SLINGSBY SAILPLANES LIMITED, KIRBYMOORSIDE, YORKSHIRE  
E N G L A N D.

TECHNICAL INSTRUCTION NO. 30

T.51 DART ALL VARIANTS

INCREASE IN TAILPLANE MASS BALANCE WEIGHT

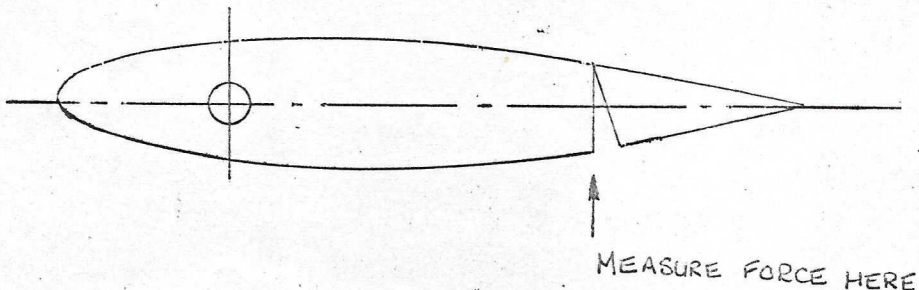
Object of the Modification: It seems likely that, in two or three incidents, Darts have suffered from fairly high-frequency pitching oscillations when flying fast. A detailed analysis of the dynamic stability confirms this possibility and indicates that a larger mass-balance weight for the all-moving tail is required.

The modification therefore consists of replacing the present tailplane mass balance weights by larger weights. This modification is to be carried out as soon as possible and in any case before the 31st October, 1967.

1. Remove the two inspection panels forward of the tailplane in the rear fuselage.
2. Remove the existing elevator mass balance weights via the inspection panels.
3. Disconnect the rear end of the elevator push rod from the lever in the rear fuselage.
4. Since there are several different types of "Dart" tailplane, the new balance weights are somewhat too large as supplied, and must be trimmed to suit each aircraft.
5. Fit the new balance weights to the balance weight arm but do not tighten the attachment bolt fully.
6. Fit the tailplanes.
7. Measure the force which has to be applied to the root rib of the tailplane, immediately forward of the leading edge of the tab, to bring the tail to its neutral position.

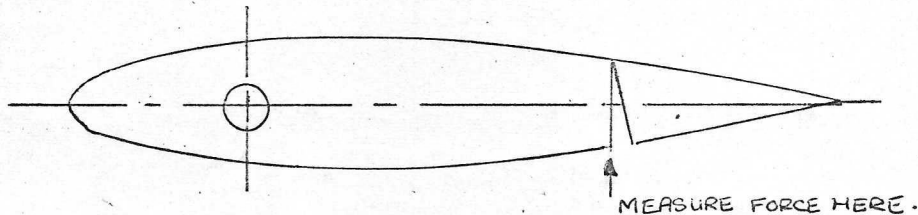
8. Trim the balance weights, taking roughly equal amounts off each, until the upwards force, measured in the manner described above, is between 1 and 1.25 lb (0.45 to 0.56 kg).

Be careful to allow for the effect of friction by taking the mean of the forces which (a) just allow the trailing edge to rise and (b) just push it down.

9. Tighten the balance weight attachment bolt and reconnect the elevator pushrod. Inspect to ensure that the balance weight does not foul the adjacent structure, the push rod or trimmer cables when the tailplane is at the limits of its movement.
10. Check the adjustment of the elevator bias spring attached to the elevator push rod in the vicinity of Frame No. 3 by ensuring that the upwards force which has to be applied to the root rib of the tailplane, just forward of the leading edge of the tab, to bring the tail to its neutral position, is between  $5\frac{1}{4}$  lb and  $5\frac{3}{4}$  lb (2.38 kg to 2.60 kg).
